ACP-2019-72

## Moray West Offshore Wind Farm

CAP 2232

## Chart Showing Extension of Existing Moray Firth TMZ

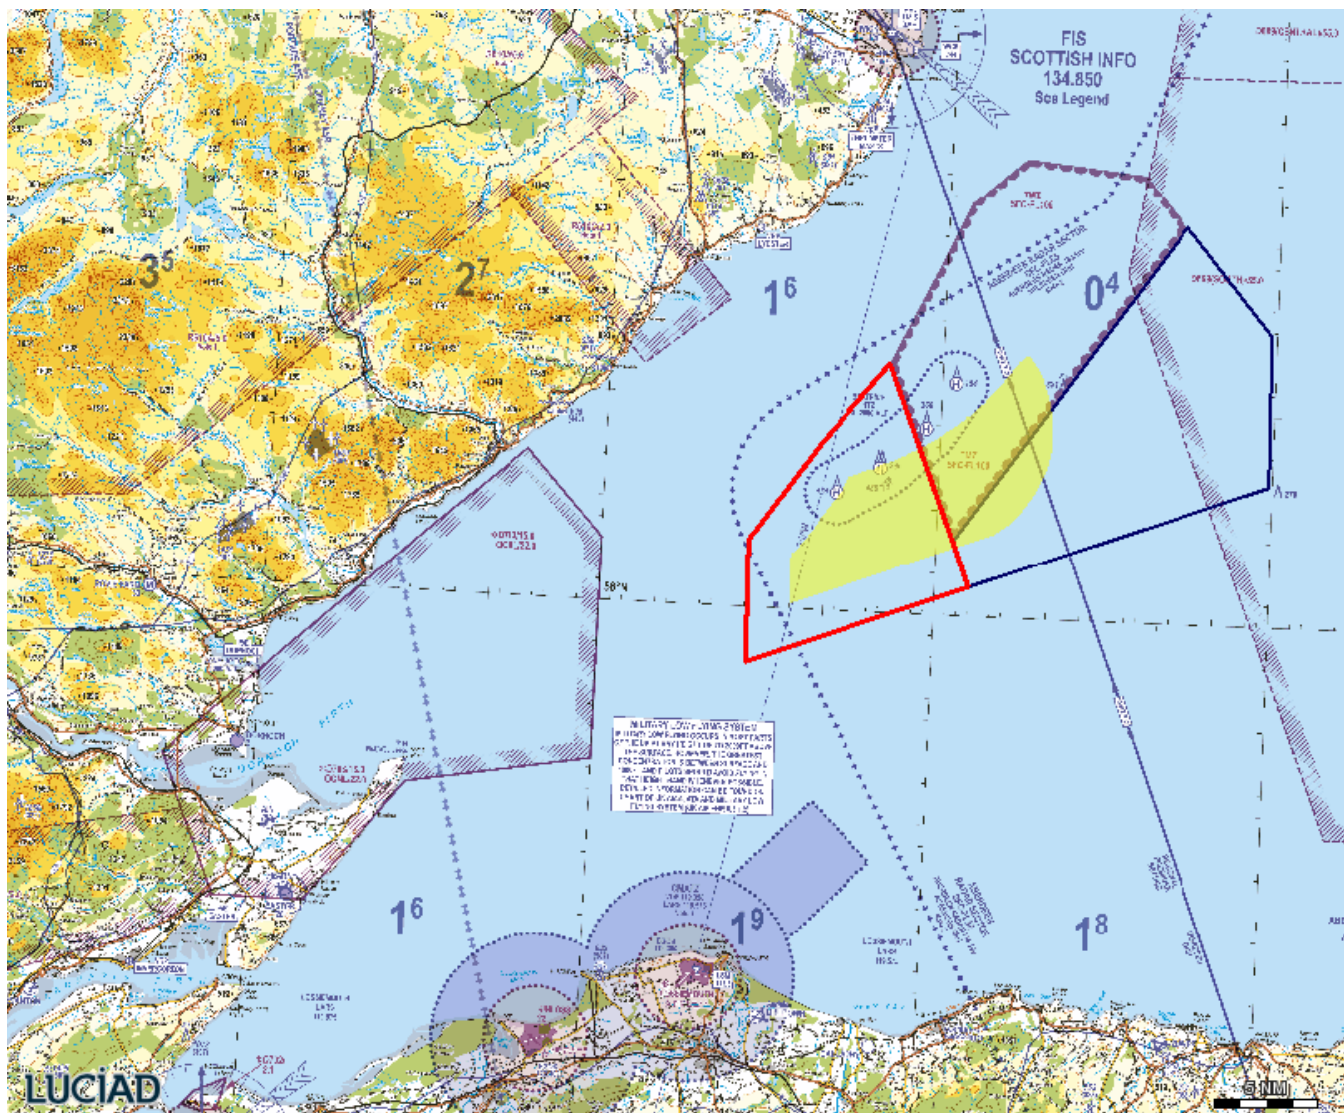
- 4.5 In considering the formal submission by MOWWL with respect to ACP-2019-72: Moray Offshore West Wind Farm the CAA recognises the requirement to mitigate the negative impact of the planned WTGs through the use of radar blanking to the Alanshill PSR and **APPROVES the proposed extension of the Moray firth TMZ** to enable traffic operating in the Moray West area to remain displayed to ATC through the use of SSR returns.
- 4.6 The design of the TMZ is to be as described and illustrated in the document 'Moray West ACP V1.1' published to the CAA Airspace Change Portal on 10 May 2021.

- 4.7 The planning consent granted to the Moray Offshore West Wind Farm development requires a PSR mitigation strategy to be agreed prior to construction of WTGs and stipulates that the mitigation is to be implemented and in operation prior to erection of the WTGs. MOWWL indicate that construction is due to commence in 2024.
- i) **Condition 1:** Prior to the implementation of the TMZ described, considered and approved within this proposal, MOWWL must confirm the target AIRAC and provide the up-to-date draft AIP amendment to the CAA for approval. The TMZ must be implemented and operational before the erection of any WTGs.

- i) **Condition 2:** Prior to the implementation of the TMZ described, considered and approved within this proposal, MOWWL must ensure all relevant LOAs are updated and accepted by the CAA.

- i) **Condition 3:** Prior to the implementation of the TMZ described, considered and approved within this proposal, a Radar Mitigation Scheme Agreement must be in place between MOWWL and the MOD. Should such Radar Mitigation Scheme Agreement not be reached this will be considered to constitute a failure to meet the conditions of the planning consent and the CAA's approval of this ACP will be rescinded. Evidence of such agreement must be provided to the CAA prior to implementation of the TMZ.
